Inquiry and Advisory Committee Report

West Gate Tunnel Project

23 October 2017

Figure 3 Daily Traffic Volumes on Millers Road and Francis Street⁷².

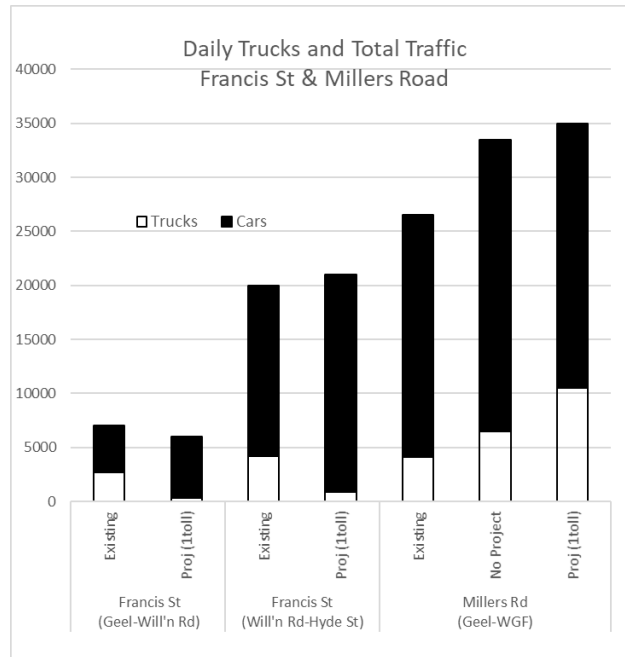
As Figure 3 shows, the truck volumes on Millers Road are already above that of Francis Street and will increase to 10,500 trucks per day (30 per cent trucks) with the Project and a single toll point. By comparison, the EES shows that Footscray Road outside the port under existing conditions carries in the order of 39,000 vehicles per day with 8,000 trucks per day (21 per cent)⁷⁶. Footscray Road outside the port is an 8-lane divided road plus service roads.

Figure 4 Urban Renewal and Key Policy Areas

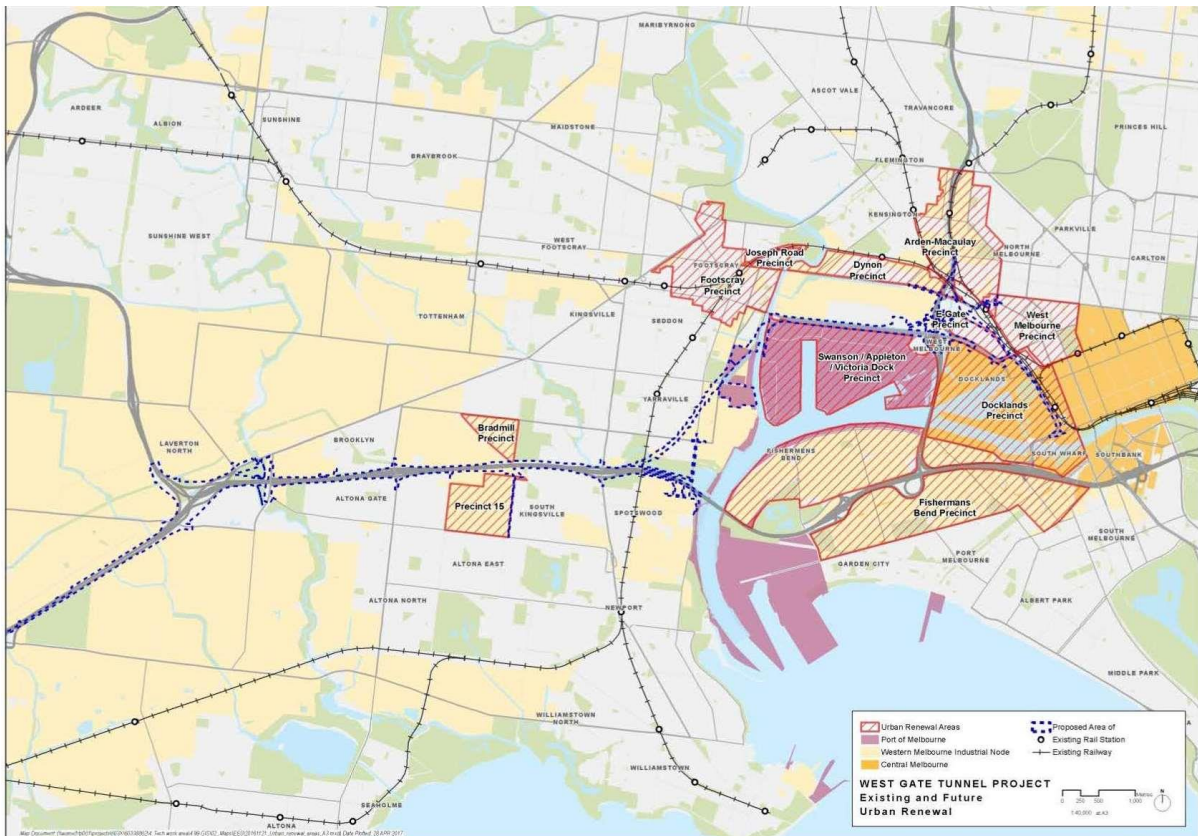
The IAC requested Mr Barnes to review *Figure 7 – Urban renewal areas and key strategic policy areas* from Technical Report K¹²² which is reproduced below.

Mr Barnes agreed that the plan accurately portrays the location and extent of urban renewal areas identified in planning policy. He agreed with the proposition put by the IAC that the alignment of the Project as reflected on the Plan, and in particular the location of the crossing of the Maribyrnong River, has been responsive in minimising impacts on the designated urban renewal areas. He accepted that impacts have been minimised by the alignment following the existing M1 corridor to the West Gate Bridge and then via tunnelling under Yarraville.

Figure 5 Photomontage of undercroft

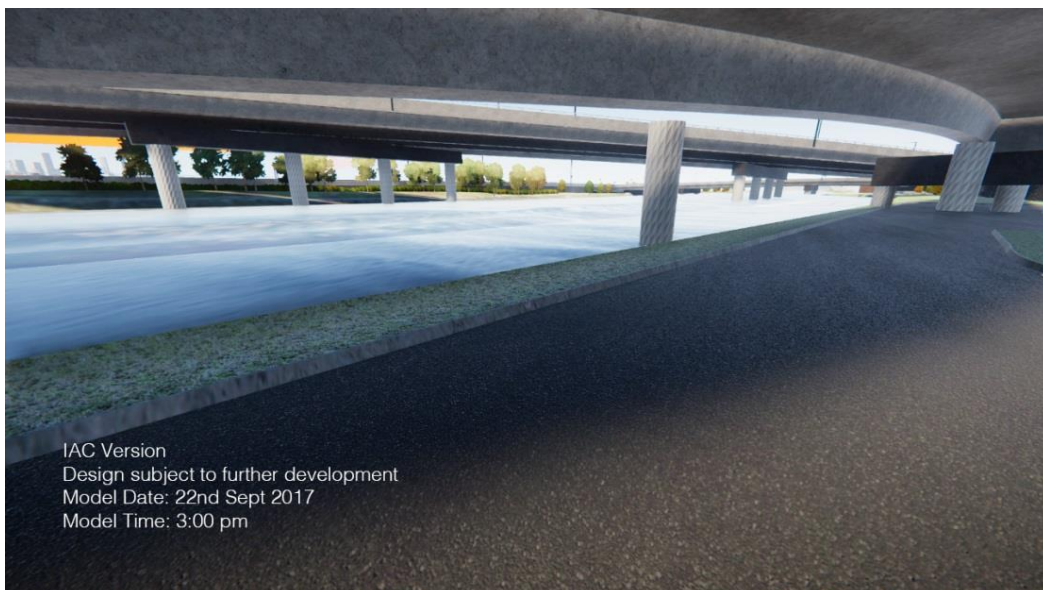
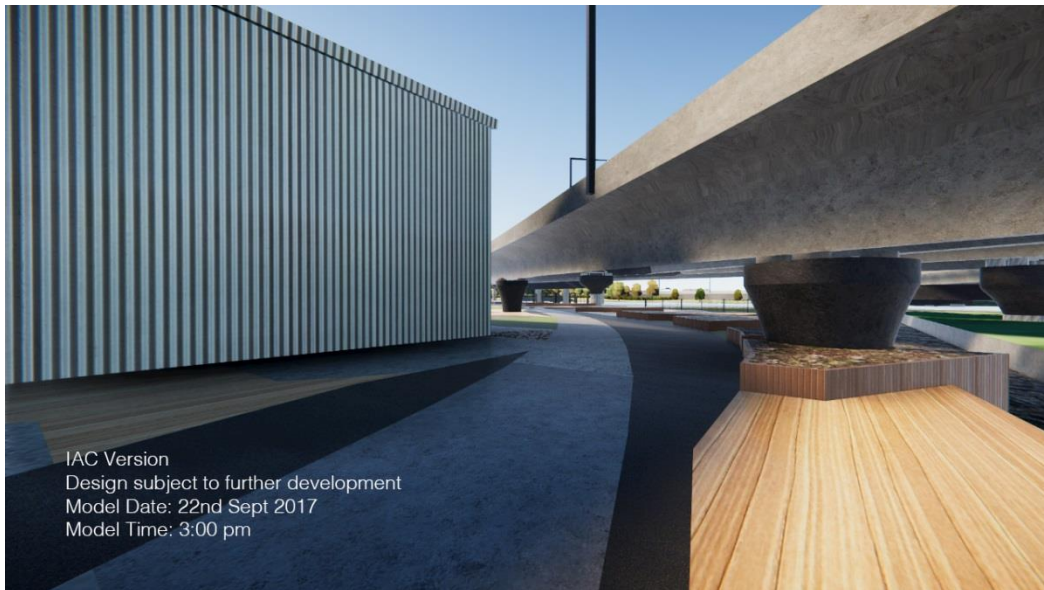
Under questioning by Counsel assisting the IAC, Mr Wood conceded that these dark colours may contribute to a sense of the undercroft areas being darker, and concurred that ramps clad in a lighter colour would diminish this concern. The 3D model allowed consideration of the visual impacts of the parapets of the bridges and ramps by considering the structure without and with its parapets (Figures 7 and 8). The IAC notes verbal statements from the WDA confirming that these have not been designed as noise walls; however, they will ameliorate noise somewhat in the riverside environment.

On the west bank of the Maribyrnong River, the IAC is concerned that the bridge and its ramps will have a significant impact on the riverside. The IAC concurs with the view that the main bridge has merit but this is compromised and partly obscured by the northern ramp from important viewpoints such as the Maribyrnong foreshore south of Shepherd Bridge (refer Figure 6). Collectively, the bridge and ramp structures will change the visual composition, diminishing the prominence that the river currently enjoys looking south from Shepherd Bridge and the nearby riverside promenade. The mass of the structure will also overwhelm the contribution made by views of the city skyline from the riverside south of the Napier Street railway bridge (refer Figure 5) and create a number of areas with highly constrained visual catchments and potential entrapment points (refer Figure 6). The IAC welcomes the concession of Mr Wood that the ramps may be lighter in colour to diminish the visual impact but is of the view that this alone would not adequately mitigate its intrusion or the extent to which it obscures the main bridge. The IAC considers that Ms Bauer's suggestion to minimise the bulk of the ramps and use transparent materials where possible may further assist in mitigating the negative impacts of the bridge and ramps. Further, the IAC notes that this area will need careful management to ensure it does not acquire a reputation as an unpleasant place where anti-social behaviour occurs.

12. Review the design of the ramps on either side of proposed Maribyrnong Bridge to minimise visual bulk and incorporate transparent panels on bridge parapets.
13. Fund a masterplan for a linear reserve along the Moonee Ponds Creek between Dynon Road and Footscray Road including the proposed open space west of the Creek. The plan should be prepared by the relevant land manager in consultation with the City of Melbourne, Melbourne Water, and other relevant authorities, the Friends of Moonee Ponds Creek and the Moonee Ponds Creek Co-ordination Committee.
